New Reactors Division – Generic Design Assessment

Step 4 Assessment of Mechanical Engineering for the UK HPR1000 Reactor

Assessment Report ONR-NR-AR-21-004
Revision 0
January 2022

Figure 4: RP schedule interactions

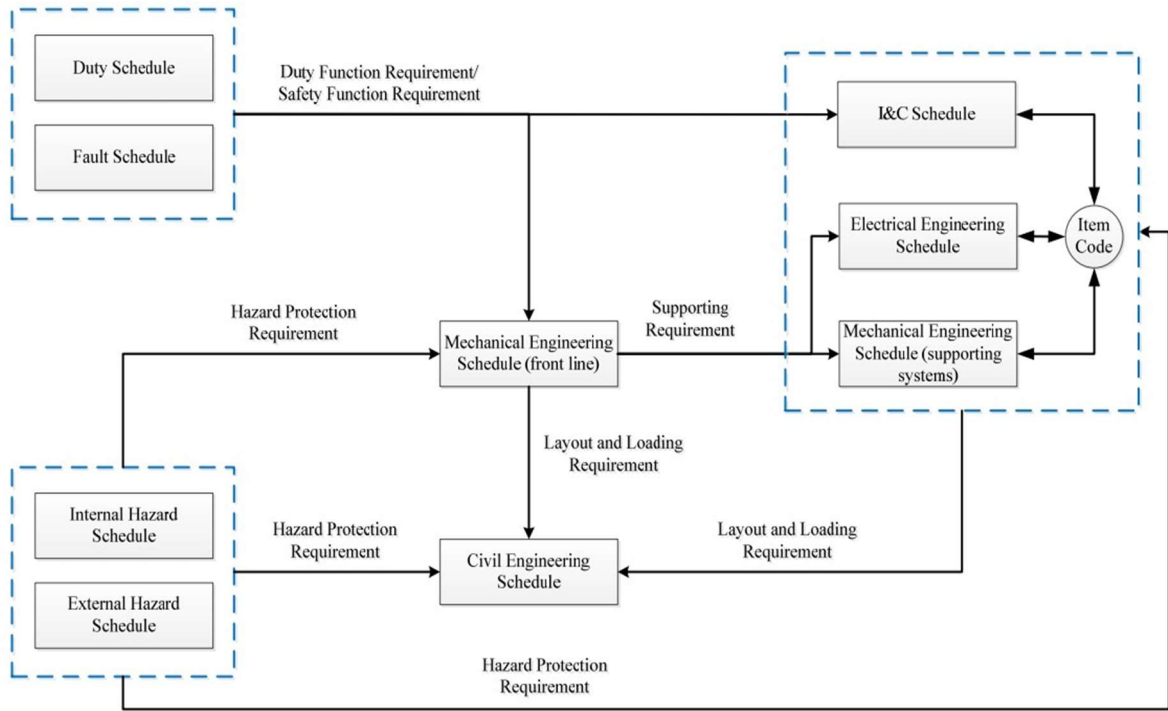
189. The ME Schedule (see (Ref. 51), part number RISi250EX) identified the RHR heat exchanger performance requirement as 8.963 MW. However, the RP could not show its engineering basis of design (design basis).

193. I consider this a shortfall against ONR SAP SC.4 (Safety case characteristics). Detailed design information, beyond what was practicable during GDA, will be required to provide the demonstration. I have raised this as an Assessment Finding:

AF-UKHPR1000-0129: The licensee shall, during detailed design, produce a strategy and plan to justify the Mechanical Engineering design basis for all safety related systems and components. From this, information shall be provided for an agreed sample to address the following:

Figure 7: RCV [CVCS] reactor coolant pump seal injection safety function classification

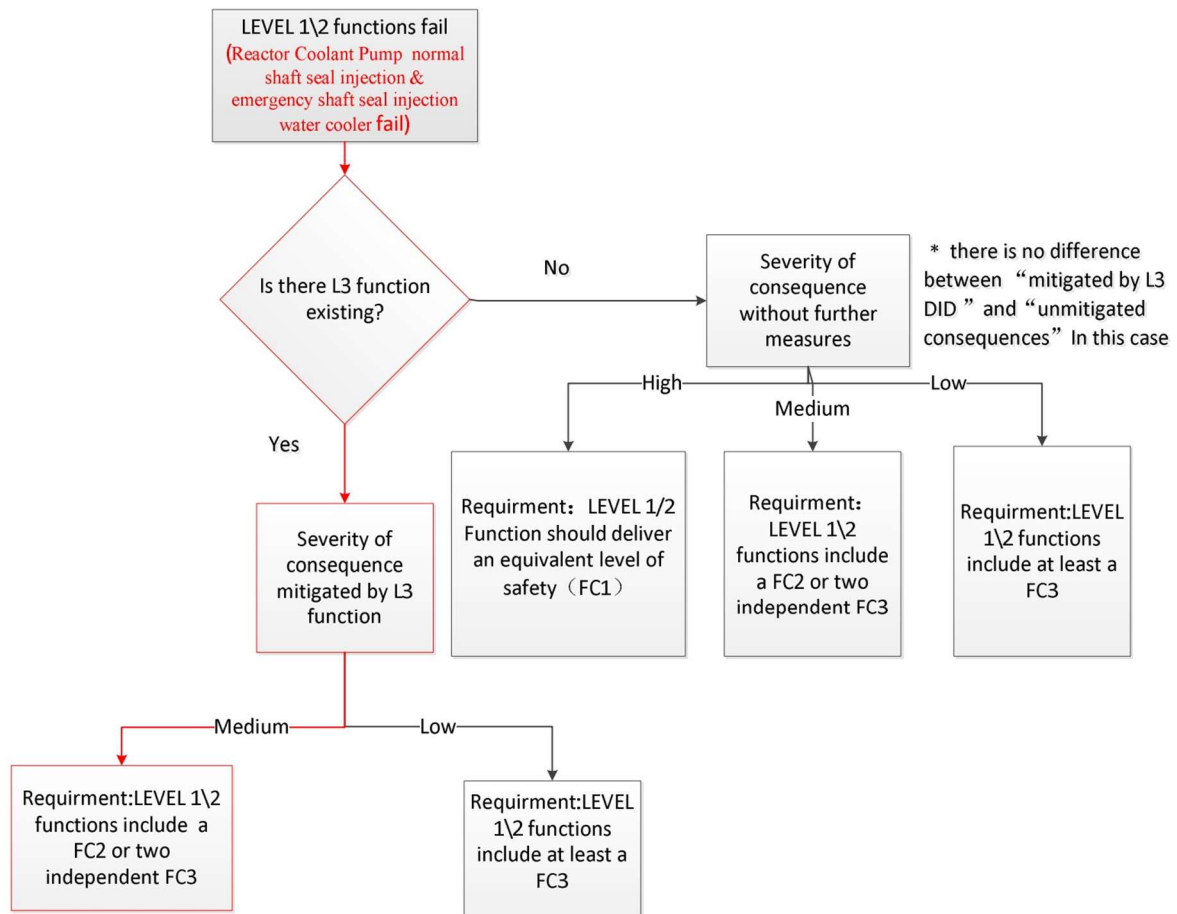
- 207. As noted, the RCV [CVCS] is designated as providing a Category C safety function. I queried the suitability of this given the integrity of the shaft seal is a Category A safety function.
- 208. During a technical meeting in May 2021 (Ref. 7) the RP explained its approach. Figure 7 details its decision-making process. Following this approach results in a 'medium' consequence if a Level 3 safety measure is successful.

Figure 8: Reactor coolant pump closed-loop seal injection schematic

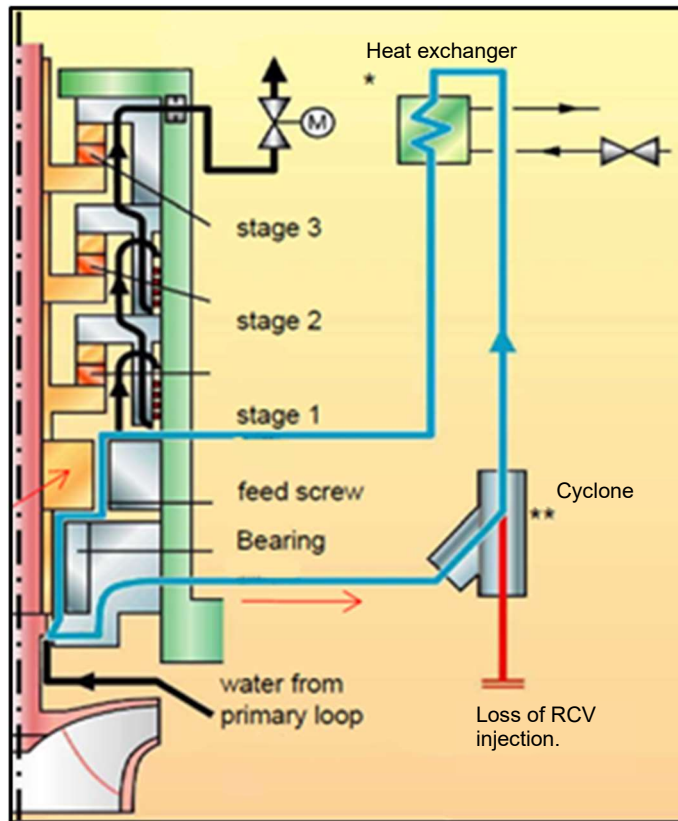
209. Figure 8 details the shaft seal injection arrangement. The RP explained that upon loss of the RCV [CVCS] shaft seal injection function:

- A passive feed-screw on the reactor coolant pump maintains seal injection fluid flow.
- This flow cools the seal via the RRI [CCWS] heat exchanger at a reduced pressure.
- The filtration of the shaft seal injection is lost.
- The RIS [SIS] exists as a further Level 3 protection measure upon loss of seal integrity.

210. Hence upon loss of the RCV [CVCS], the original cooling and filtration safety functions are lost. The cooling function is maintained via the reactor coolant pump's feed-screw and the RRI [CCWS] heat exchanger.

Figure 10: EHR [CHRS] back-flushing schematic

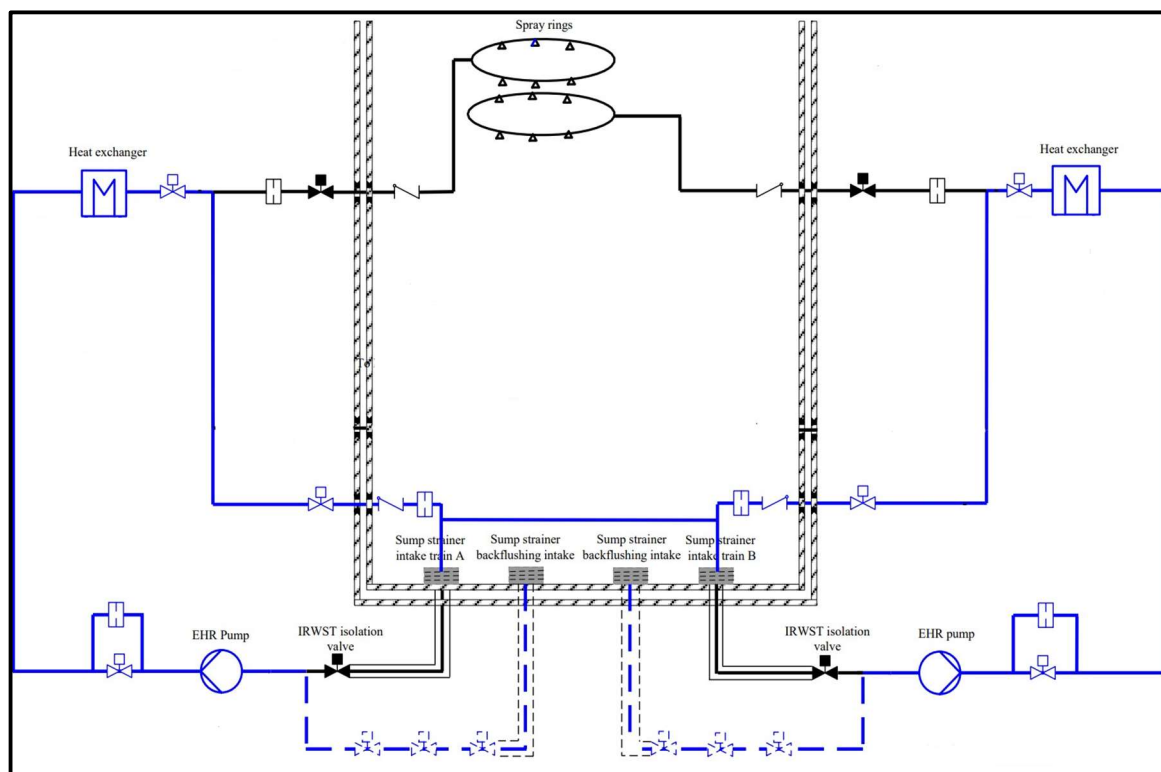
267. I applied ONR SAP SC.2 (Safety case process outputs) to the EHR [CHRS] back-flushing safety case (Ref. 68). I could not identify the method of back flushing the strainer. RQ-UKHPR1000-1580 (Ref. 6) was raised to seek clarification.

268. The RP responded by including a schematic (Figure 10) within its safety case (Ref. 69).

269. I consider that adding this schematic sufficiently explains the back-flushing arrangement.

Figure 14: MHSI pump seal flush schematic

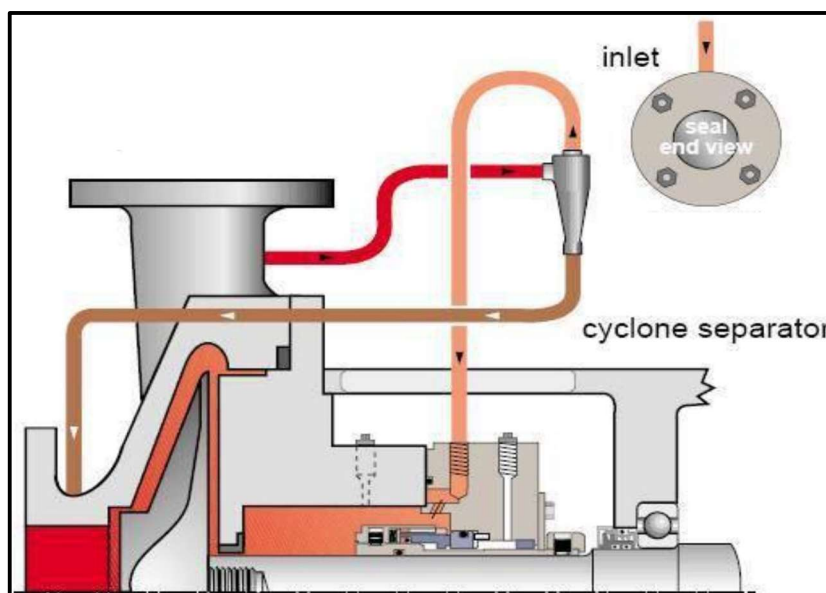
- can operate indefinitely with a 15 ml/h leakage rate;
- seal leakage is collected via the Nuclear Island Vent and Drain System (RPE [VDS]) system. The leakage volume can be determined by the liquid level of the RPE [VDS] tank; and
- uses a cyclone separator to remove particulate from the pumped fluid (see Figure 14). This function will be subject to equipment qualification.

340. I consider this response acceptable subject to suitable qualification. I consider this to be normal business.

Figure 15: VDA [ASDS] silencer schematic

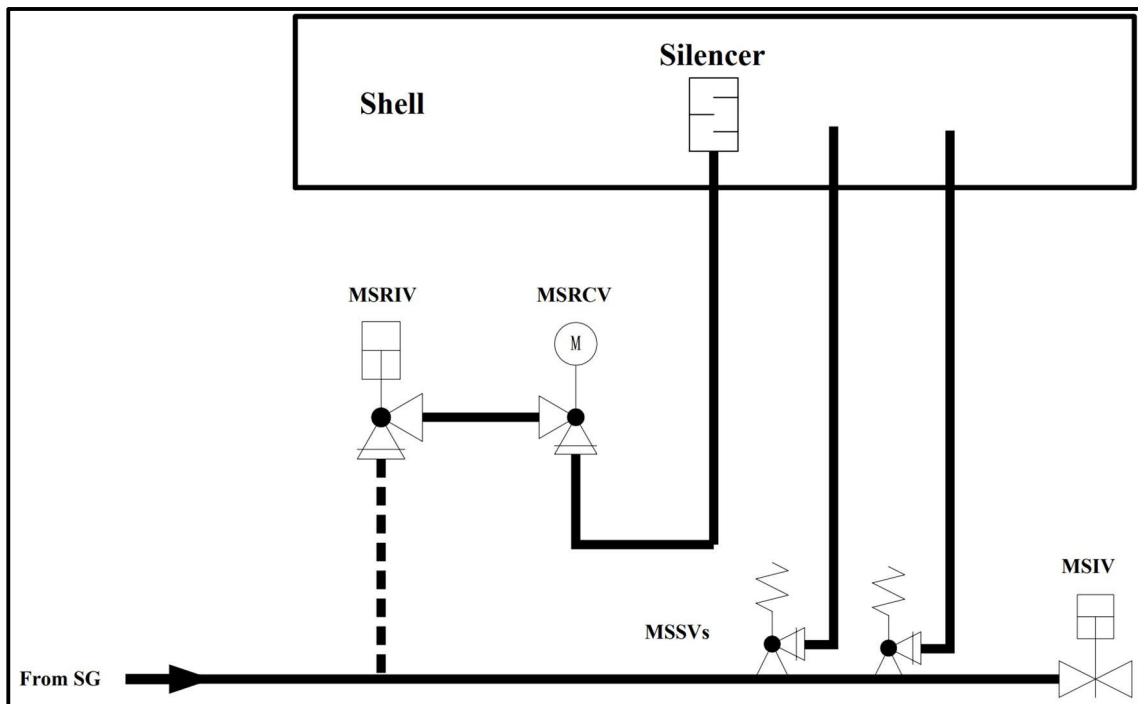
363. The silencer design pressure is 5.4 MPa(g). I could not identify how the design pressure related to the maximum upstream pressures. RQ-UKHPR1000-1153 (Ref. 6) was raised to seek clarification.

Figure 18: HSG253 sample, system modifications

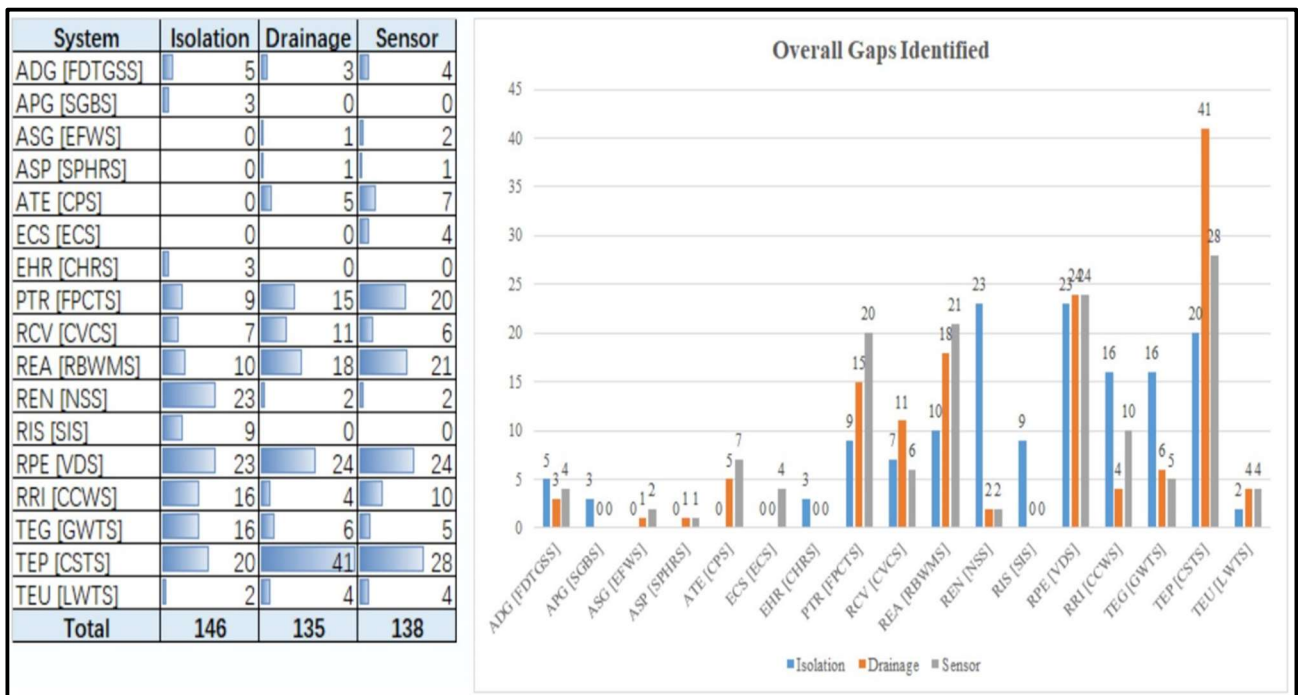
653. The RP subsequently applied the learning from the above four systems (TEU [LWTS], RIS [SIS], ASG [EFWS] and VVP [MSS]) to applicable fluid systems. This led to the following fluid systems design improvements (see Figure 18):

- Isolation – 146 design modifications identified
- Drainage – 135 design modifications identified
- Pressure monitoring (e.g. pressure gauges) – 138 design modifications identified

654. Design modification M62 (Ref. 148) considers the above fluid system changes.

Figure 19: Inspection access to RHR via pass partition plate

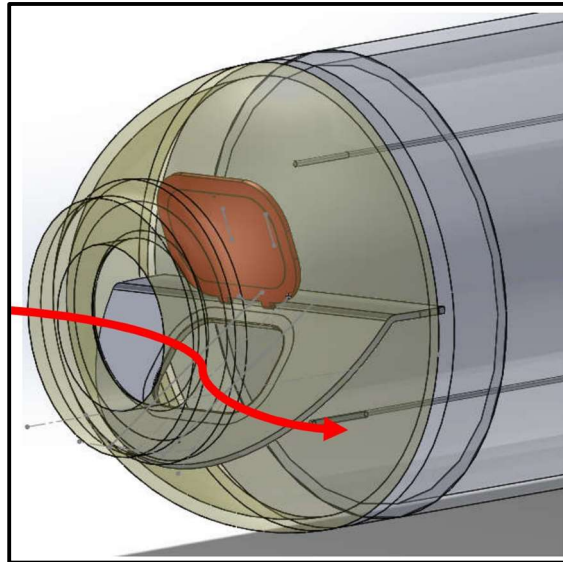
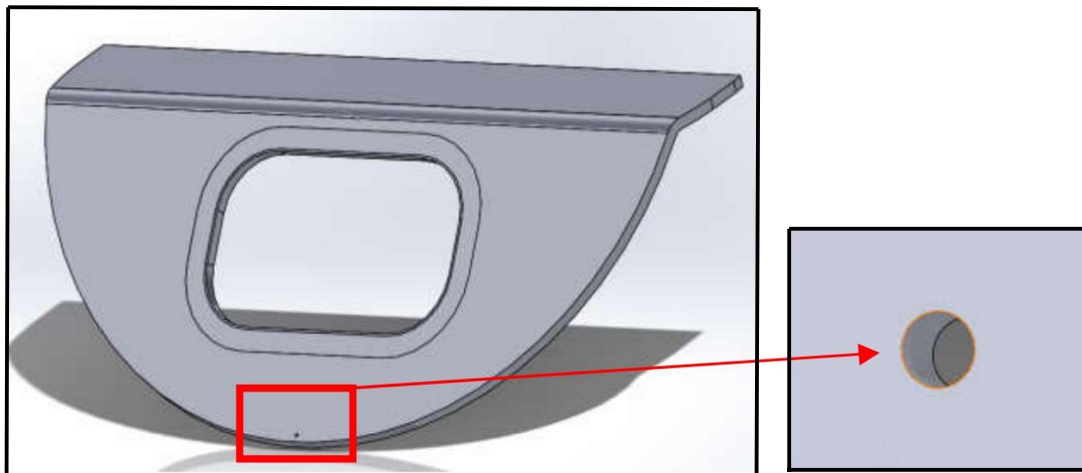
685. The RP responded stating:
- the pass partition plate design enabled inspection via a hatch (Figure 19);
 - the hatch is appropriately secured and sealed; and

- a 6 mm through hole (Figure 20) drains primary circuit fluid retained by the pass partition plate.

686. I am satisfied the measures for securing and sealing the hatch are proportionate. This is subject to seal leakage qualification during site-specific stages, which I consider to be normal business.

Figure 22: Diagram of spent fuel cask and inner cannister

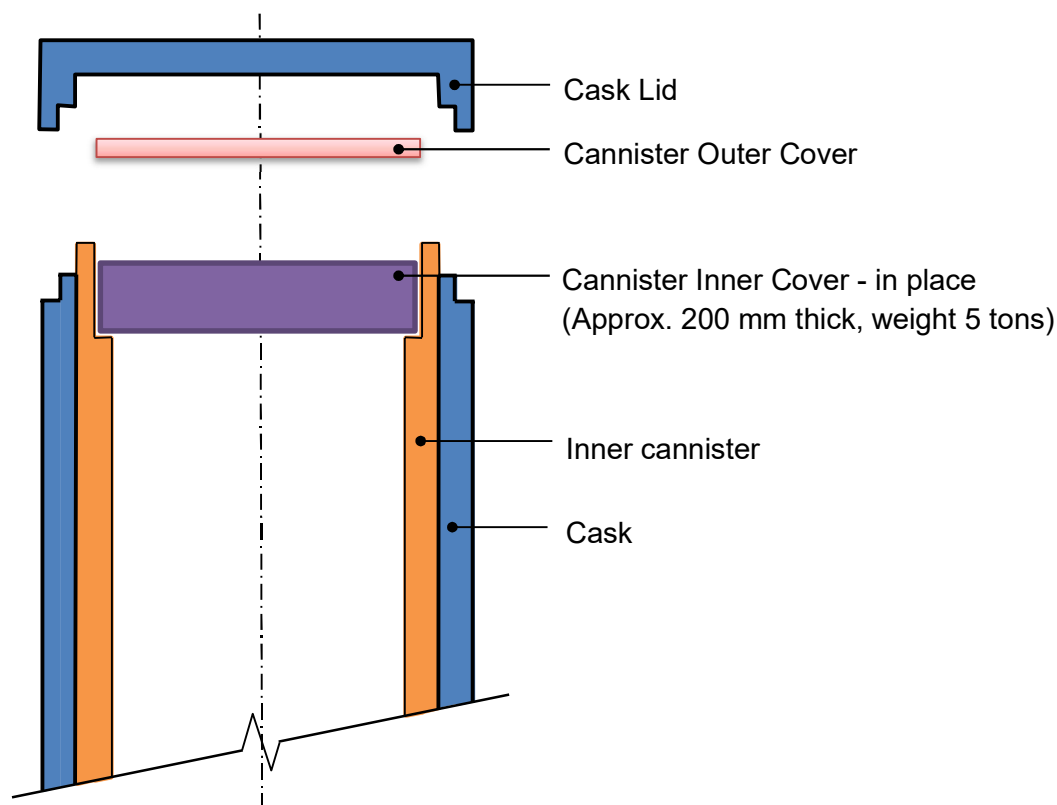
903. I noted that when the filled cask is lifted from the Loading Pit to the Cleaning Pit, the inner cover is not secured to the cannister and the outer cover and cask lid are not fitted (see Figure 22).

904. I raised RQ-UKHPR1000-1583 (Ref. 6) to address queries relating to the cannister lid operations.

Figure 24: Spent Fuel Pool overtravel protection

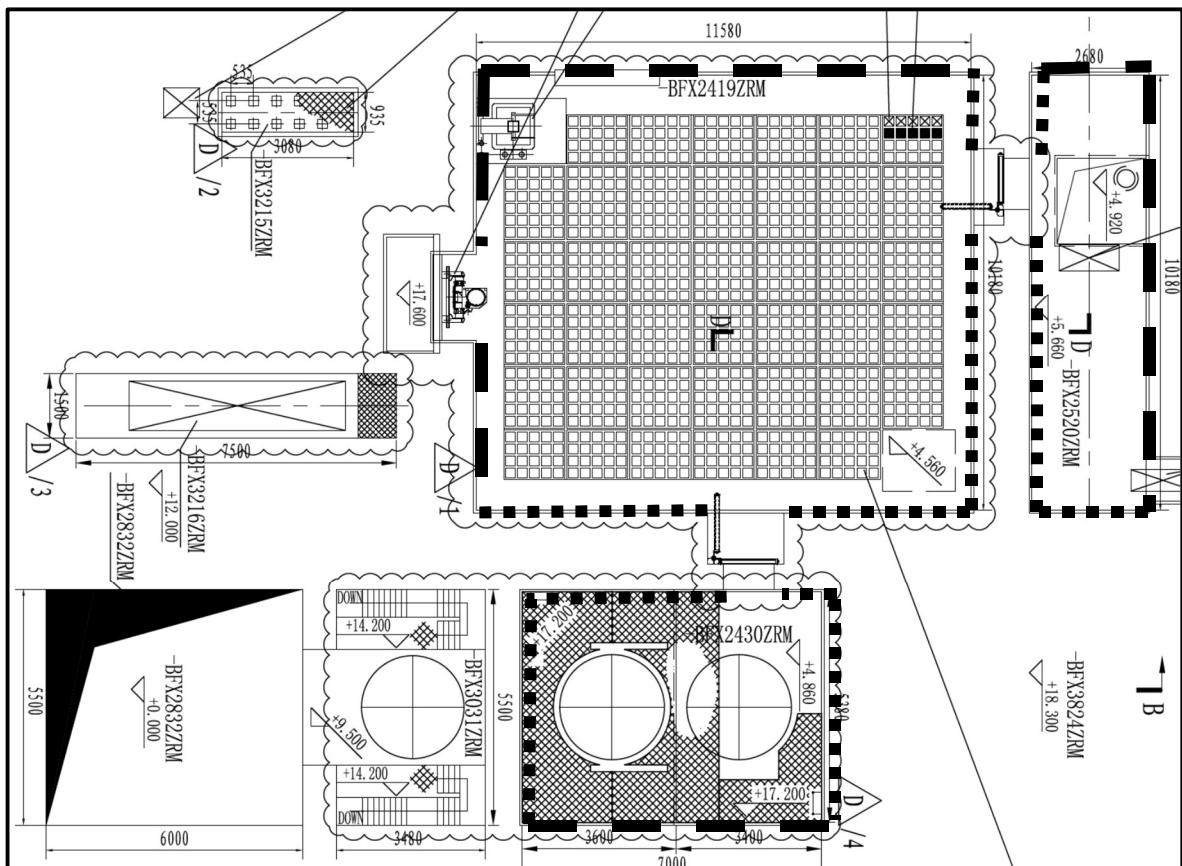
- I consider the mechanical overtravel protection against the SFPC fixed sleeve colliding with the pond walls (overtravel) to be insufficient against ONR SAPs EKP.3 (defence in depth), ECS.3 (Codes and standards) and ERL.3 (Engineered safety measures). This gap is relevant to 7 of the 12 SFP walls (see thick, dotted lines in Figure 24).

- Mechanical buffers protect against the overtravel fault on 5 of the 12 walls (see thick, dashed lines in Figure 24). The RP claims two, diverse means of mechanical protection exist (a buffer and torque limiter). Considering ONR SAP EKP.3 (defence in depth), the torque limiter does not prevent the fault. I acknowledge the torque limiter offers some protection against fault progression. Hence, when considering ONR SAP ECS.2 (Safety classification of structures, systems and components), for this fault the single Class 1 mechanical buffer does not adequately protect against overtravel.

- The SFPC fixed and telescopic sleeves are not currently claimed as safety measures to protect the fuel being damaged following a collision. However, I noted the RP's arguments do make claims on the integrity of the sleeves in its safety case (Ref. 60). The sleeves are neither classified nor substantiated. Hence, further consideration of the safety functions of the SFPC fixed and telescopic sleeves is required in line with ONR SAPs ECS.1 (Safety categorisation).
